RANS

Assembly Alert: 172

Subject: Incorrect shipping of AAPQ-44 rivets – Oct 1, 2009 thru Dec 15, 2010

FIGURE AA172

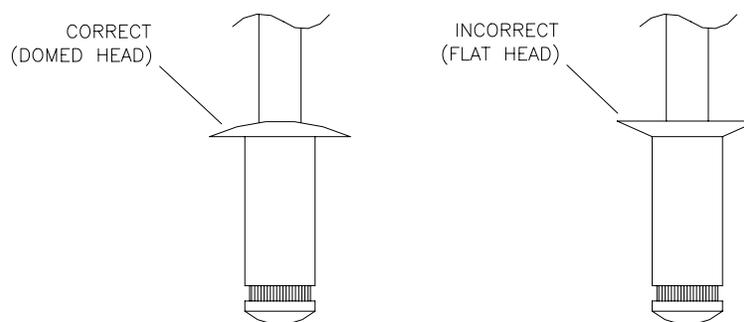
1/8" Flush Rivets may have been shipped instead of AAPQ-44 1/8" Aluminum Rivets.

A box of Flush Rivets was received from our supplier labeled as AAPQ-44 rivets and placed in stock.

Flush Rivets are made for counter-sink applications and are not designed for applications requiring a protruding head such as AAPQ-44 rivet. Incorrect rivets can be identified by the flat top of the rivet head rather than a dome shape. Refer to **FIGURE AA172**.

Contact RANS Aircraft Parts Department for replacement of any incorrect rivets you may find.
